# UNITED STATES PATENT AND TRADEMARK OFFICE

APPLICATION NO.	FILING DATE	FIRST NAMED INVENTOR	ATTORNEY DOCKET NO.	CONFIRMATION NO.
10/671,367	09/24/2003	Mark W. Kroll	A03P1066	1862

<b>Office Action Summary</b>	Application No. 10/671,367	Applicant(s) KROLL ET AL.	
	Examiner Kennedy Schaetzle	Art Unit 3766

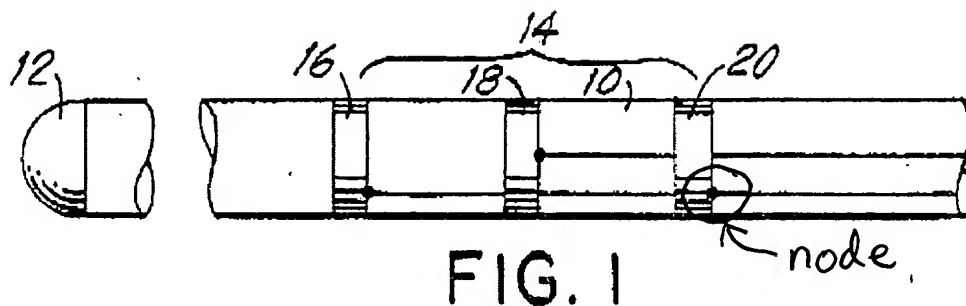
Regarding claim 9, the examiner considers the point circled below to be a node point.
